# Stakeholder Comments Template

## Transmission Access Charge Options

### February 10, 2016 Straw Proposal & March 9 Benefits Assessment Methodology Workshop

Submitted by	Company	Date Submitted
Nancy Kelly ( <a href="mailto:nancy.kelly@westernresources.org">nancy.kelly@westernresources.org</a> )	Western Resource Advocates  (Joint Comments of: WRA, WGG, NRDC, NWECA, and UCE)	March 23, 2016

Figure A: Proposed Benefits Assessment Methodology<sup>1</sup>

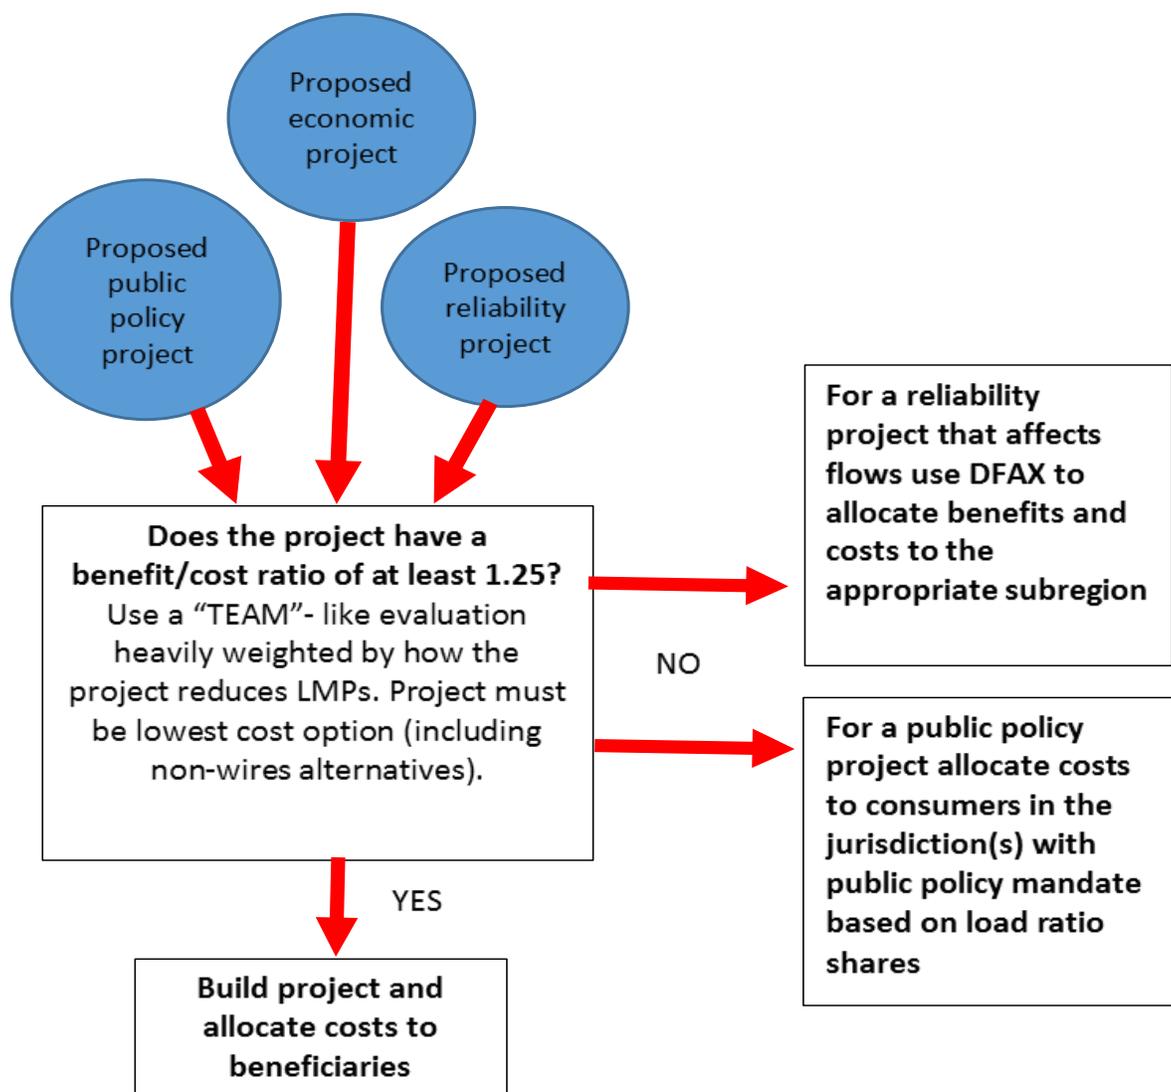
All projects are considered economic projects unless they meet other criteria specified below, and, therefore, the first measure of benefits to be applied to any project is an evaluation of economic benefits, measured as the difference in LMP prices (including congestion costs), with and without the project. While projects may be identified as needed to meet reliability criteria or needed to meet public policy objectives, the costs of the project would not be allocated in a separate manner unless one of the following conditions applied. The graphic below illustrates this approach.

- **Reliability:** Projects undertaken to meet system reliability may have no associated economic benefits. In such a situation, a different allocation method other than an economic evaluation will be more appropriate.

We propose that when a project is: (a) undertaken to maintain the ability of the RSO to meet reliability criteria, (b) the economic benefit/cost ratio is less than 1.25, and (c)

the project affects flows, that benefits are determined using a distribution factor analysis, similar to PJM's DFAX method.<sup>2</sup>

We propose that when a project is: (a) undertaken to maintain the ability of the RSO to meet reliability criteria, (b) the economic benefit/cost ratio is less than 1.25, and (c) there is no associated flow change, the project is allocated to all system participants. (We acknowledge that this situation is unlikely to arise because if the project is at a voltage level less than 345 kV, it would be allocated to the sub-region in which it resides.)

- **Public Policy:** In general, we recommend avoiding this type of distinction because of the contentious nature of allocating costs of public policy projects in the West.

Our concern noted, we propose that a project would be identified as a Public Policy Project if: (a) the project is identified as necessary to meet public policy objectives, and (b) the project has a benefit/cost ratio of less than 1.25. In that case its costs would be fully allocated to the jurisdiction or jurisdictions whose policy drives the need. If more than one jurisdictions' policies drive the need (for example, California's and Oregon's 50% RPS), costs would be allocated on a pro rata load ratio share.

If a project has a benefit/cost ratio of more than 1.25, it would be considered an economic project and its costs would be allocated based on economic benefits.

- **Economic:** Projects needed to improve system reliability, projects needed to meet public policy objectives, and projects that improve system efficiency whose economic benefits exceed costs by at least 25% are defined as economic projects and their costs allocated based on pro rata load ratio shares.
